P0766-0009

**Re: Request for Wetlands Conditional Use Permit Review
1 Franklin Ave - New Franklin School Upgrades**

To: Kate Homet, Environmental Planner & Sustainability Coordinator

Figure 1

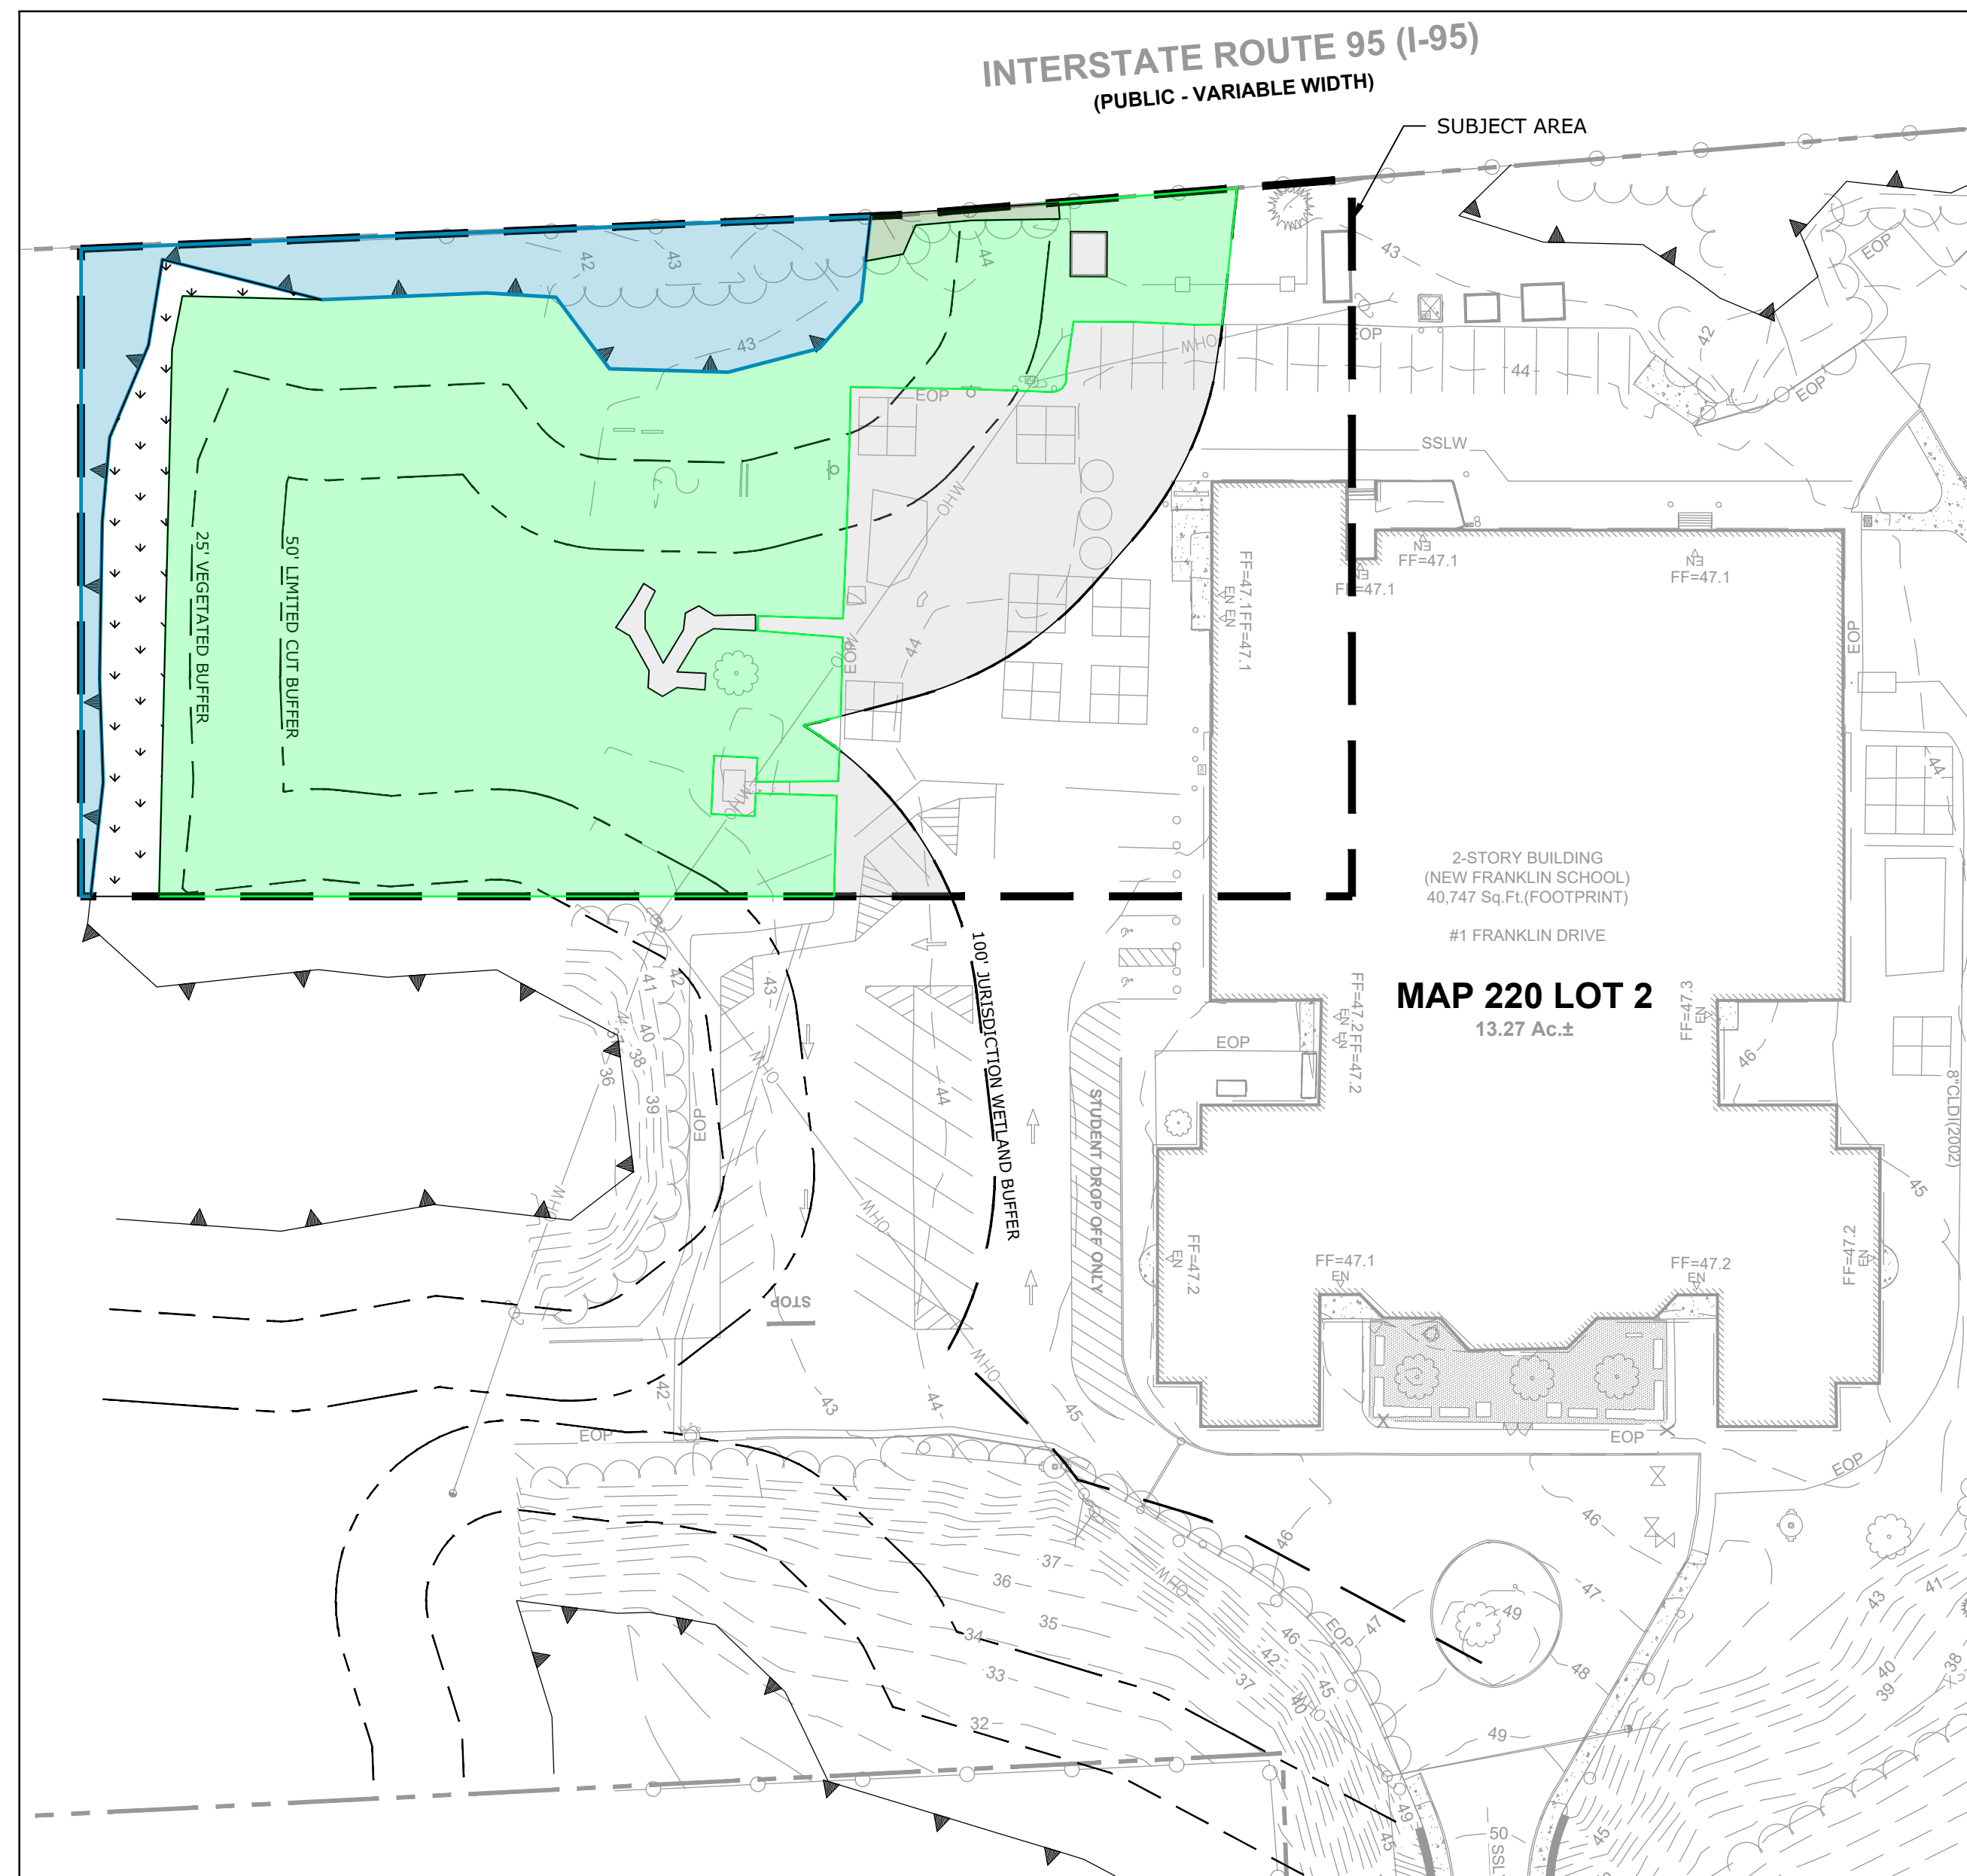
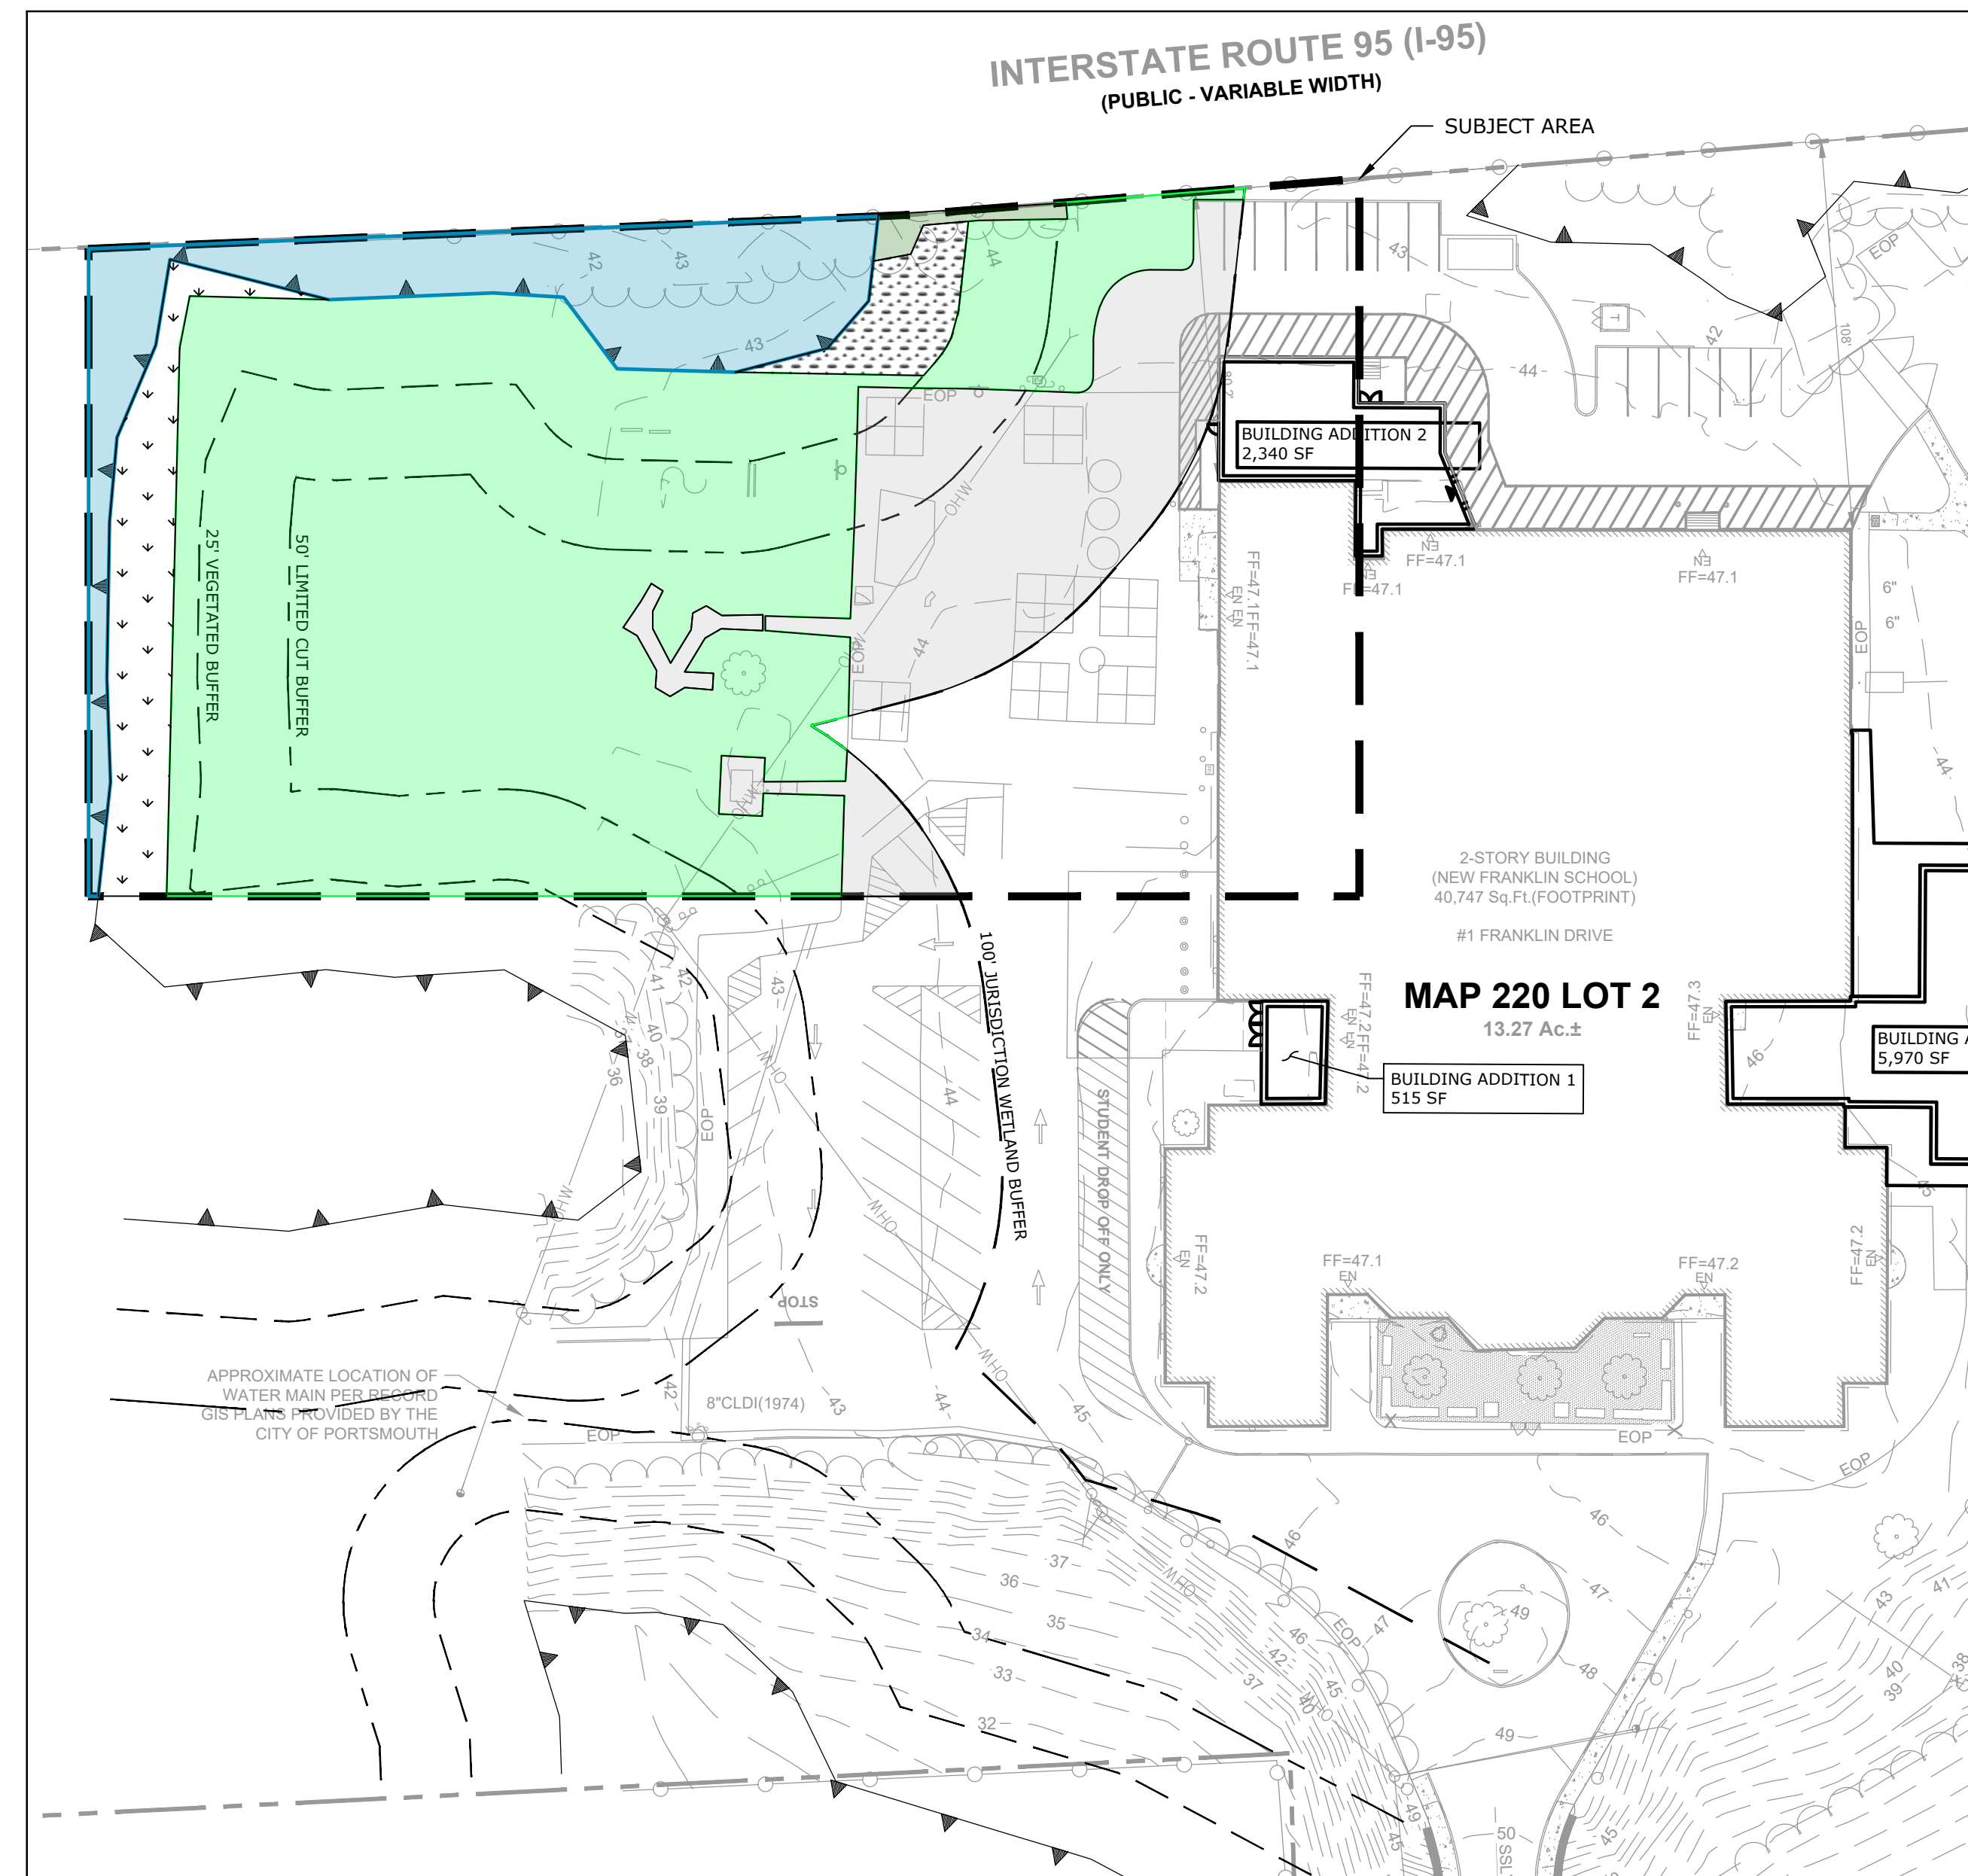
- 1. Section 10.1017.22 (3) of the City of Portsmouth Zoning Ordinance requires you to provide the following info: *More than 250 sq. ft. of alteration to the wetland buffer (regardless of the amount of alteration to the wetland): a description of the 100-foot buffer including vegetation type, the percent of the buffer with invasive species, and the percent of the buffer that is paved or developed.***

See "Wetland Buffer Surface Cover Exhibit". The existing 100' wetland buffer within the subject area consists primarily of maintained lawn/grass with impervious parking areas, and a small area of existing trees, upland wetland vegetation, and a small area identified as green ash.
